Re: Minor Permit Modification

North Cell Phase II Expansion-Area 3

Tomoka Farms Road Landfill WACS # 27540

On behalf of Volusia County, HDR is submitting the Minor Permit Modification to the Construction Permit #SC64-0078767-029 to add an underliner dewatering system as part of the construction for the Area 3 landfill expansion project. Part A of form FAC 62-701.900(1) is included in Attachment A. The application fee (\$250) per FAC 62 701.315 (1)(a) will be paid online by HDR on behalf of the Owner once FDEP logs the project into the system. As requested per email from FDEP on December 12, 2014, HDR has included a brief summary below of the proposed minor modification.

80-200

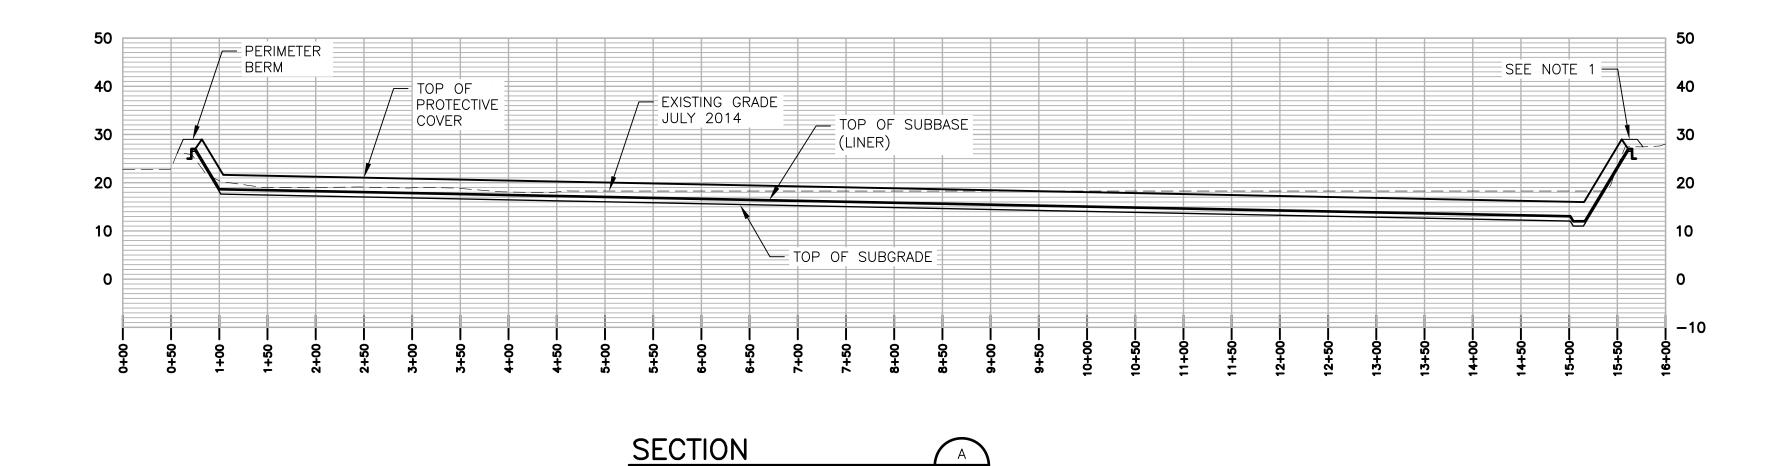
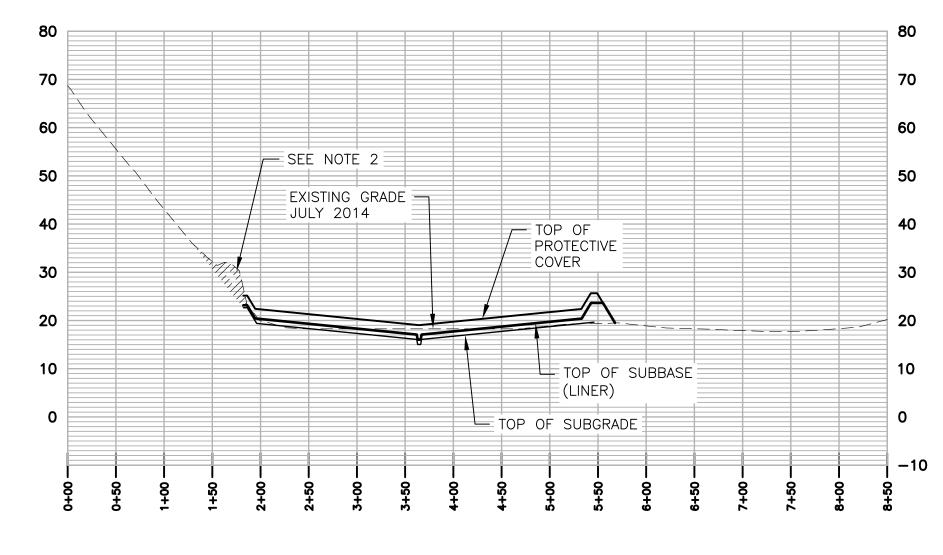
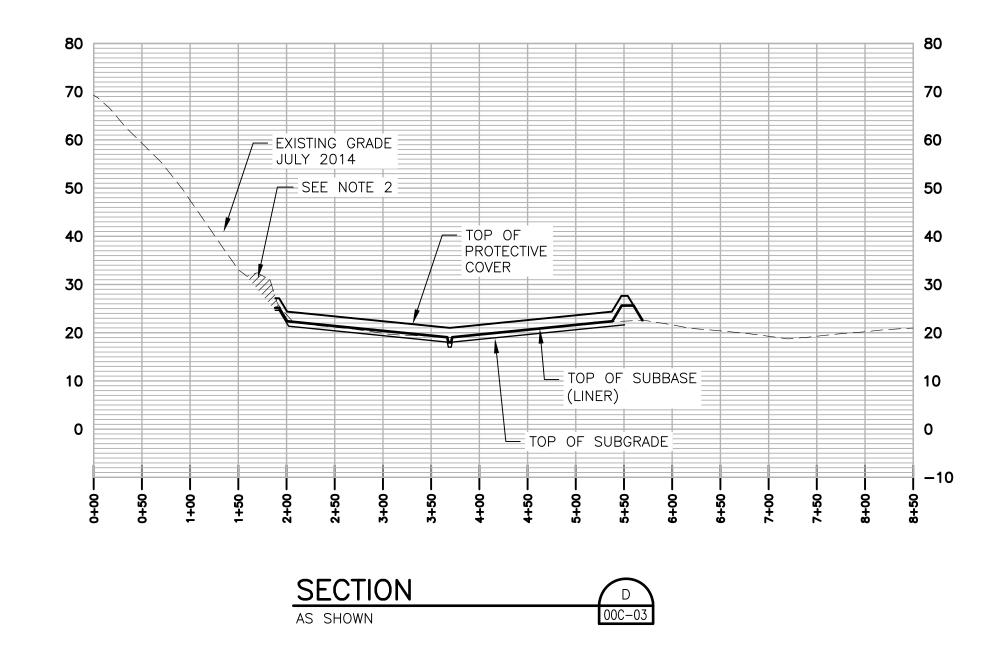
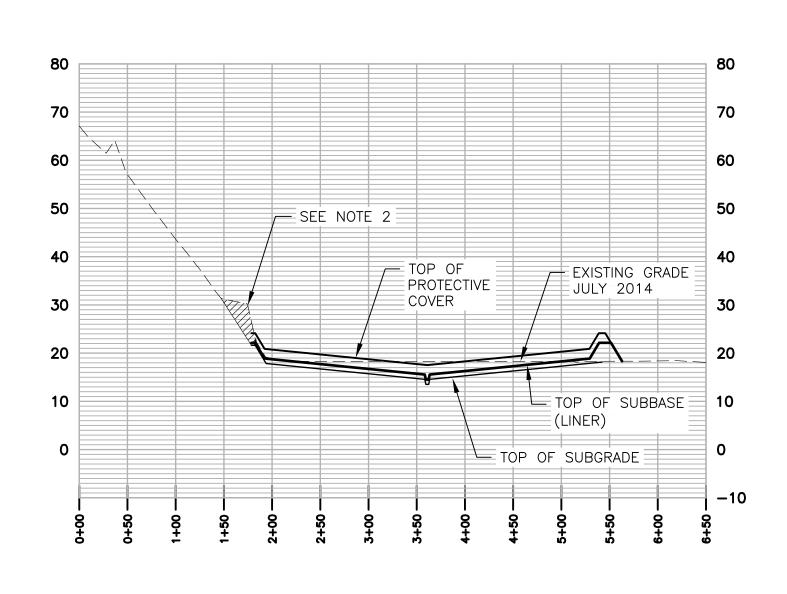
In addition, the proposed design for Area 3 includes a 6-inch HDPE perforated pipe as shown in Sheet 00C-08 that runs from the south to the north end of the cell. Sheet 00C-13 depicts several sections that include the dewatering trench. This perforated dewatering pipe is added to facilitate compaction of the subbase layer to avoid pumping of the subbase during construction. More information about this pipe can be found in Sheets 01C-02 and Detail C of 01C-03. The referenced sheets are included in Attachment B.
